Red Line Revisions to NCDH Approved Drawings

MODIFICATIONS TO
AQUA NEW YORK, INC.
WATER TREATMENT FACILITY
SEAMANS NECK ROAD
NASSAU COUNTY, NEW YORK

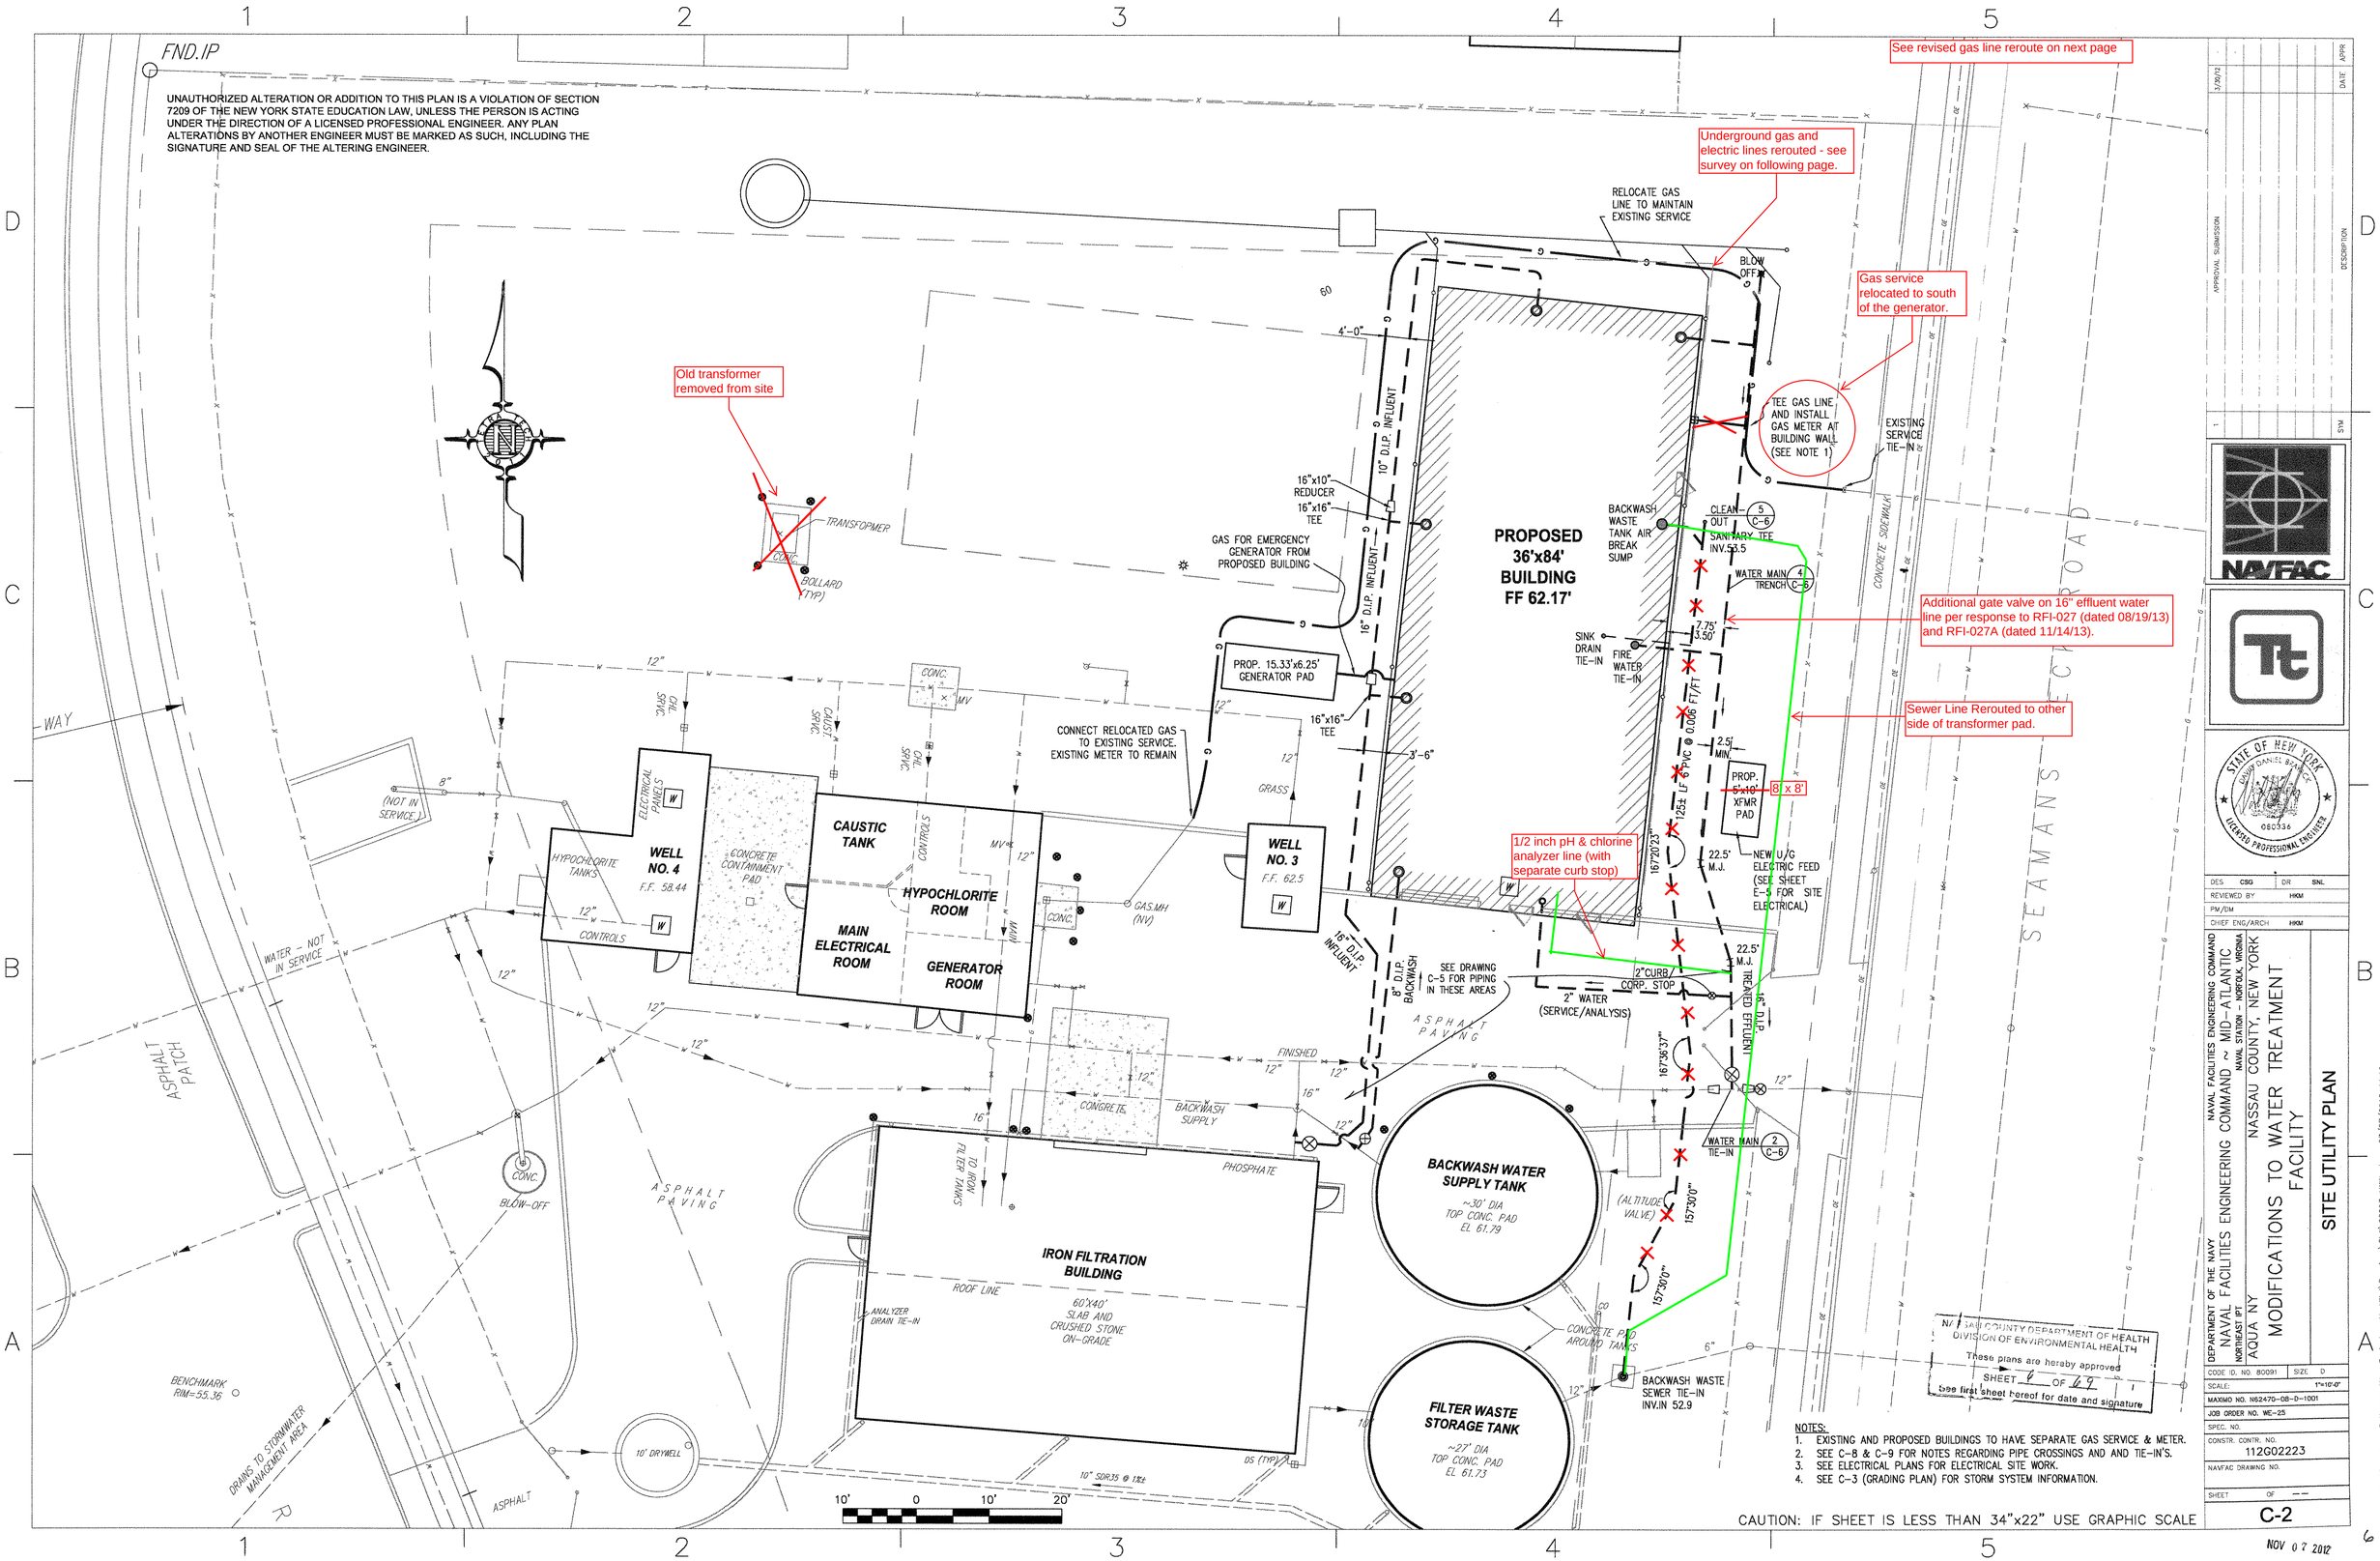
Revision to Drawing C-2: The Natural Gas line has been rerouted as shown on this drawing (per Navy's response to RFI-013 dated 2/4/2013.

3 / C-8 SECTION: **GRAVITY SEWER - PROFILE VIEW**

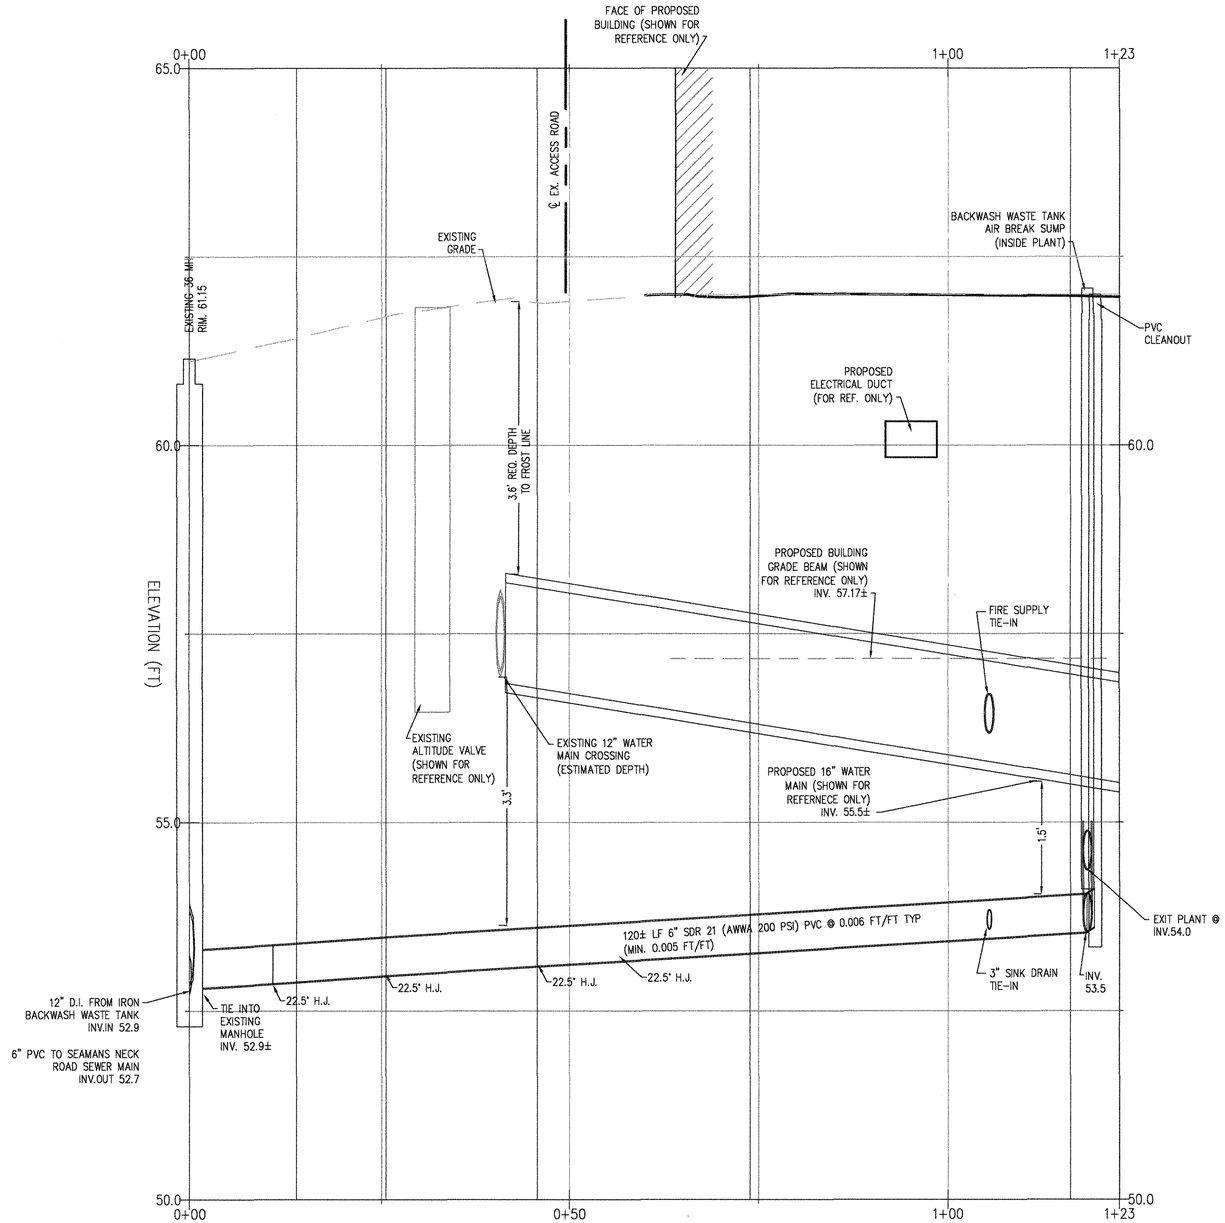
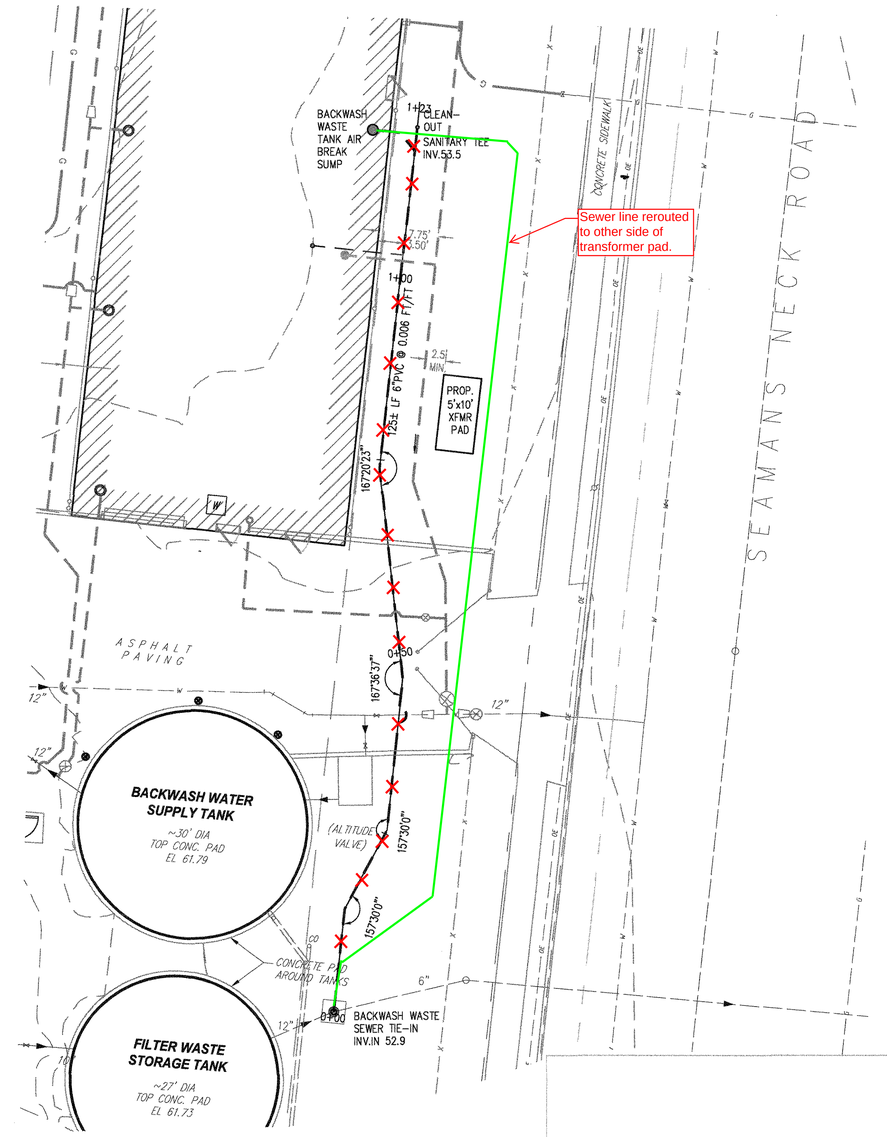
See next page for revision to the route of the sewer line.

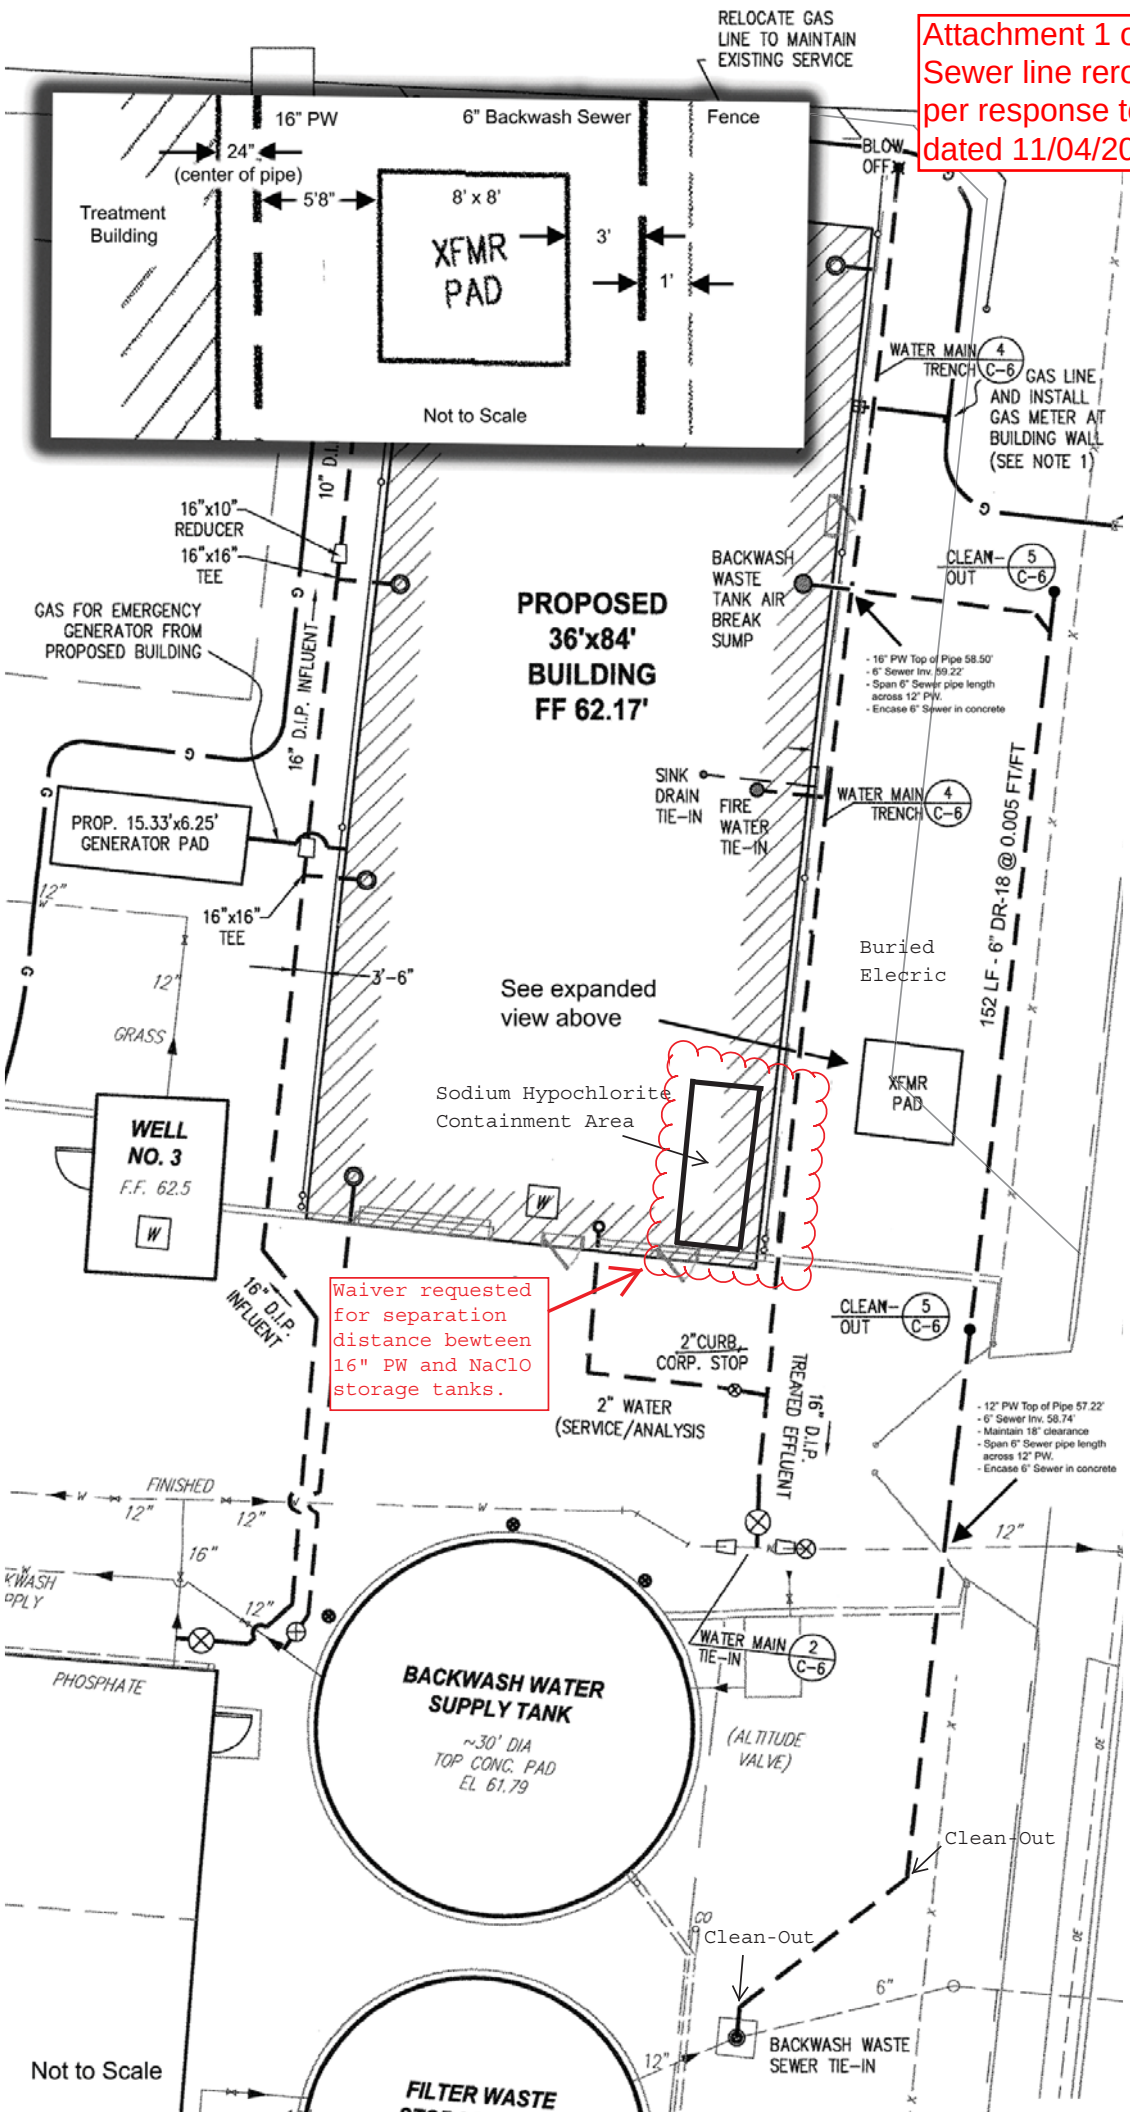
Attachment 1 of RFI-024A: Sewer line reroute accepted per response to this RFI dated 11/04/2013.

Drainage fill is AASHTO No. 57 stone, per response to RFI-034 (dated 9/5/2013).
